GRADING AND EROSION CONTROL PLAN
APPALOOSA HIGHWAY 24 SUBDIVISION FILING NO. 2
EL PASO COUNTY, COLORADO

APPALOOSA HIGHWAY 24 SUBDIVISION
FILING NO. 1A
COLORADO SPRINGS, COLORADO
COVER SHEET

Markup Summary

- ## NOTES

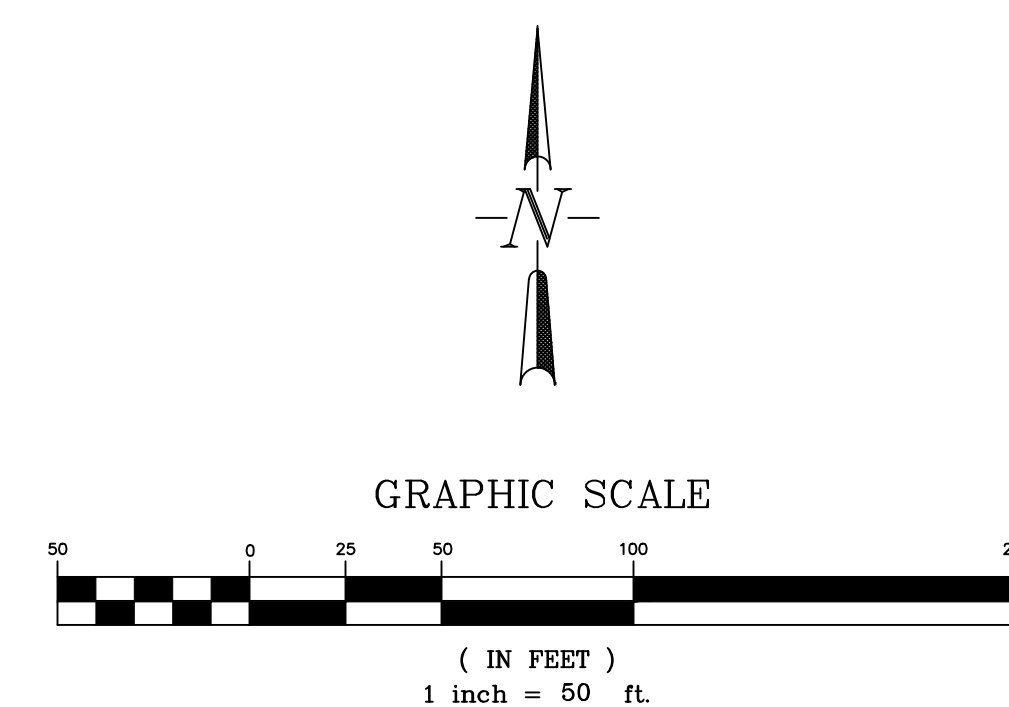
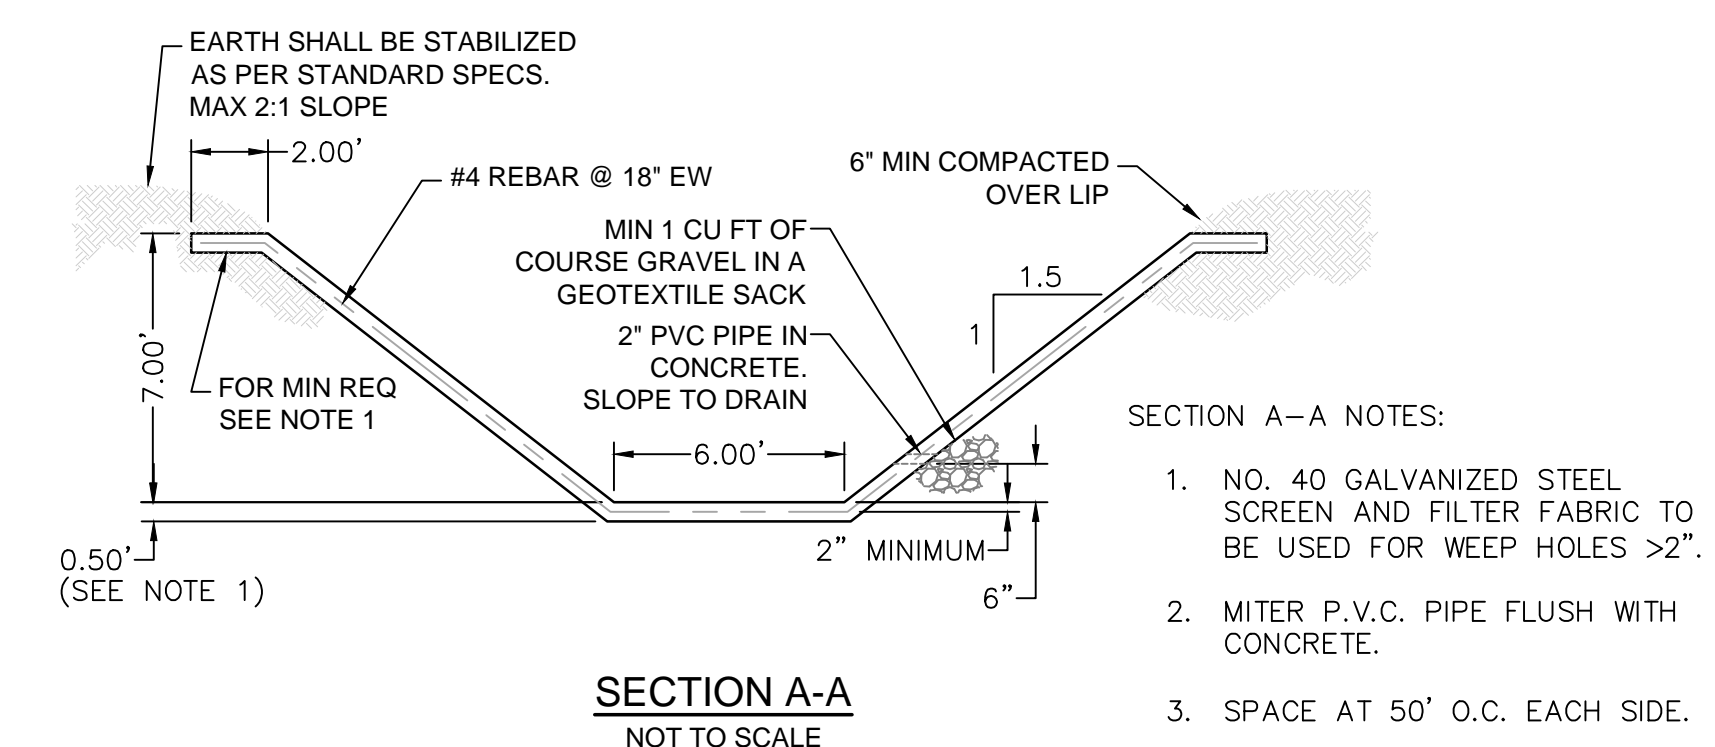
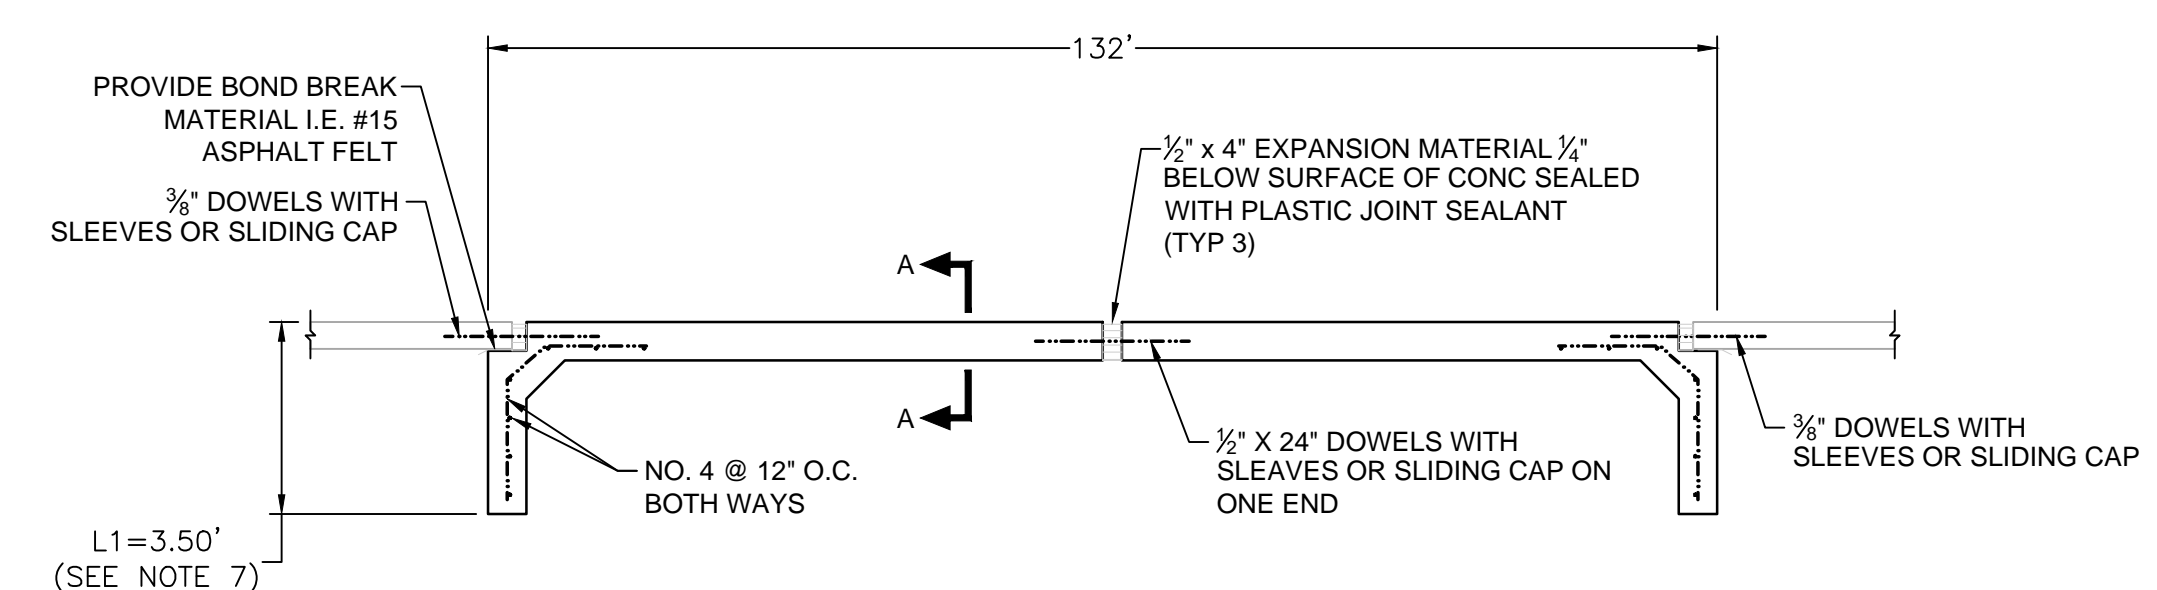
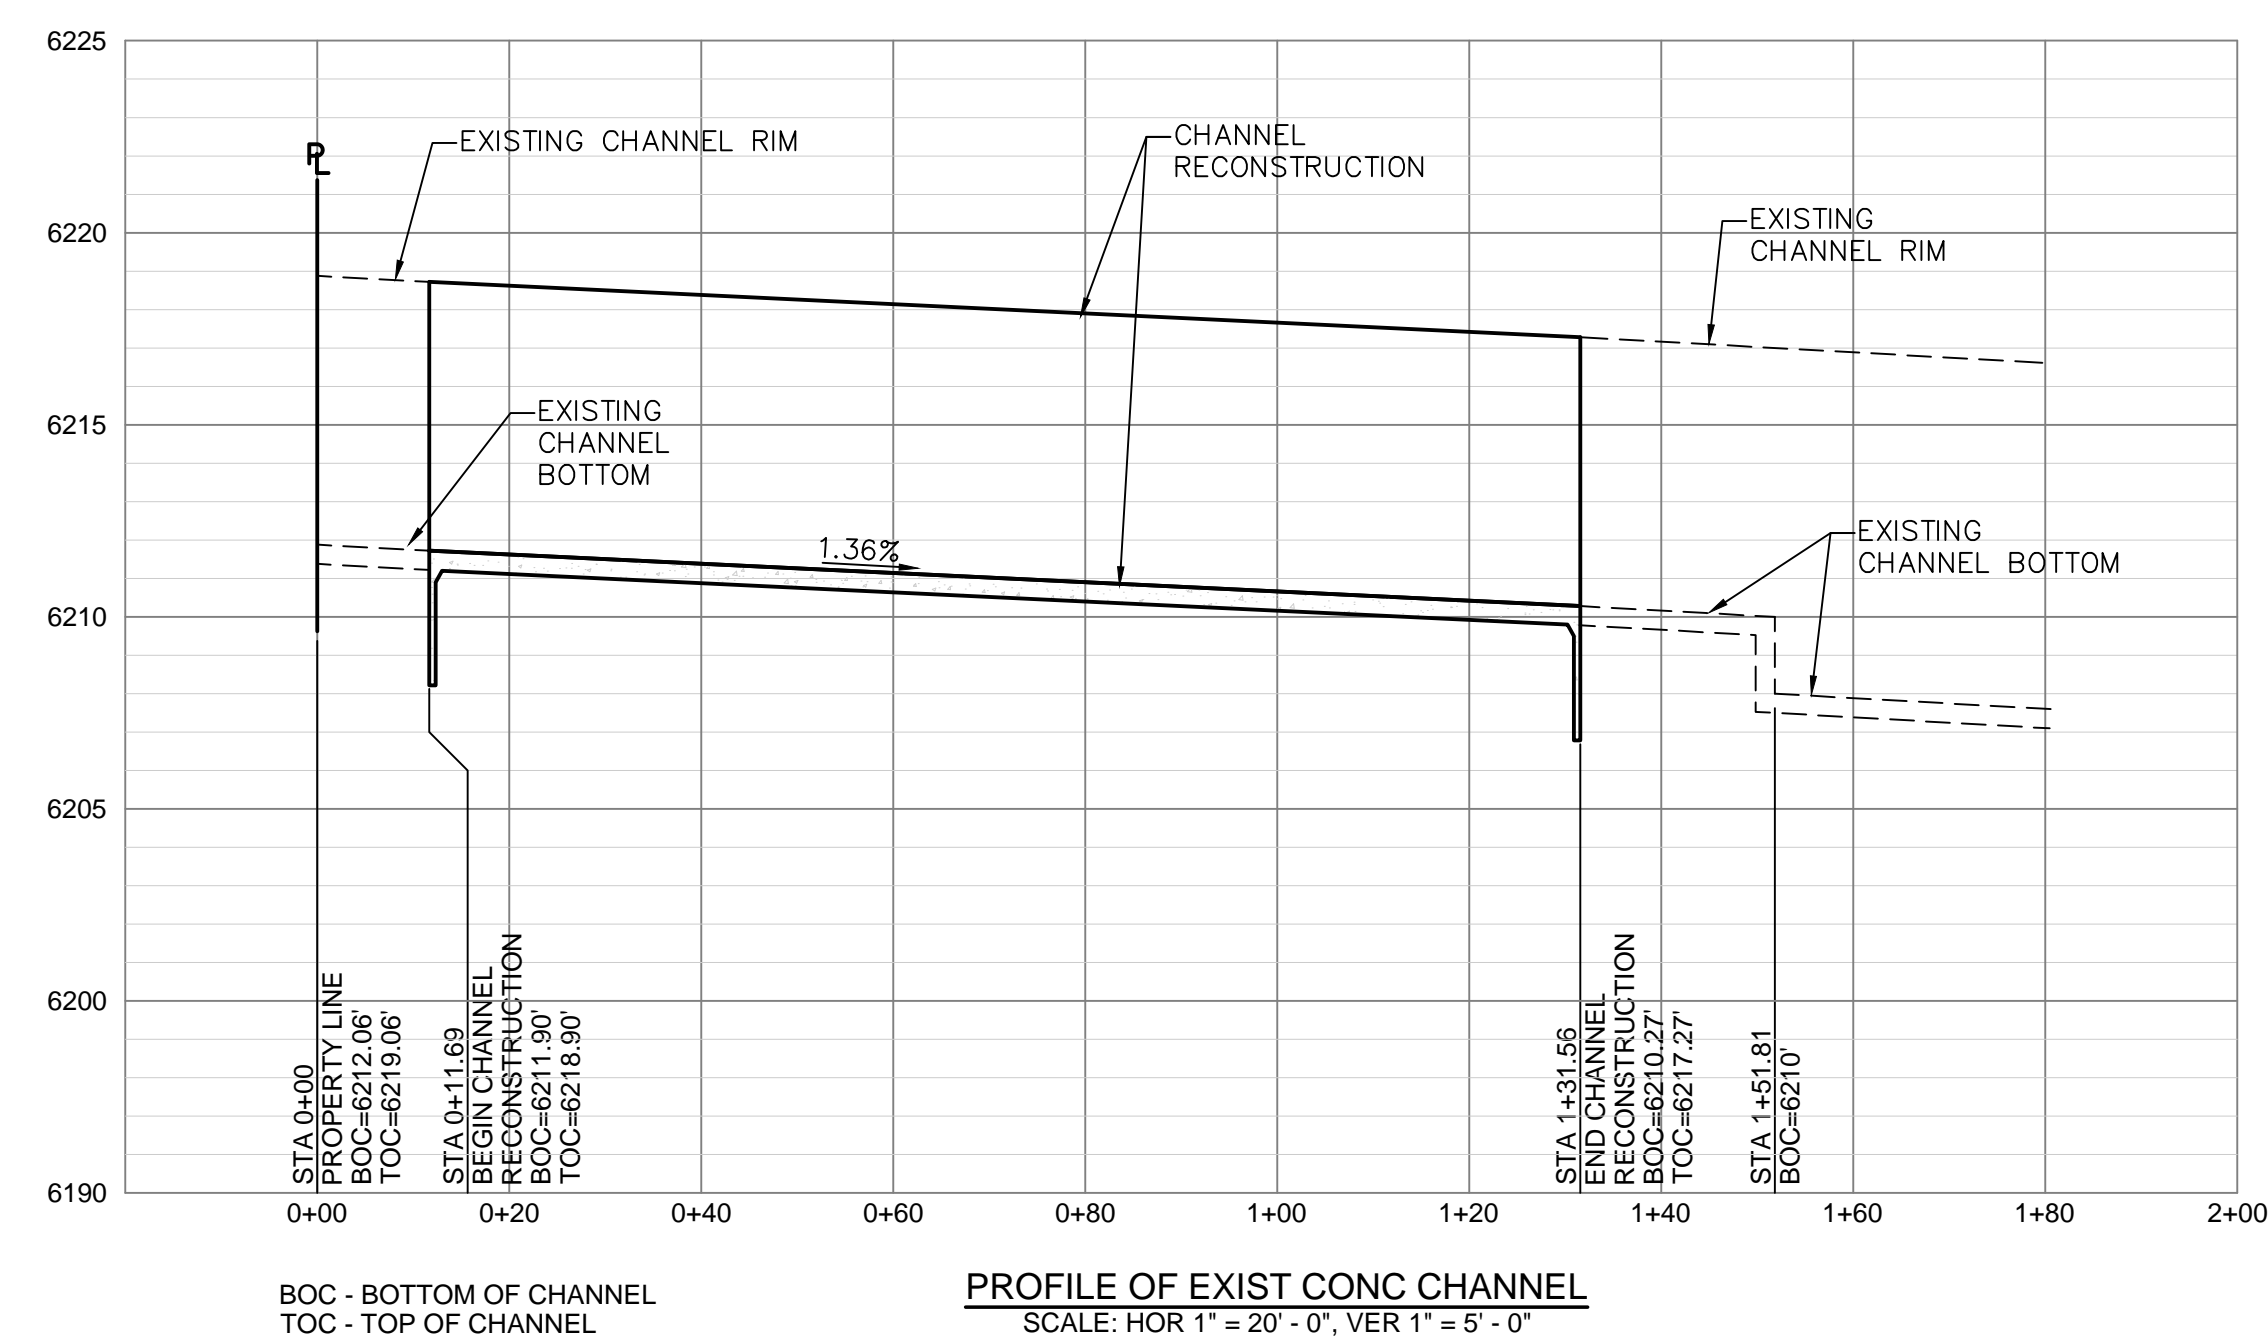
There should not be any "if" statements in the construction plans. Identify here if the design flow is super-critical or not.

What do L1 and L2 represent?

What do L1 and L2 represent?

There should not be any "if" statements in the construction plans. Identify here if the design flow is super-critical or not.
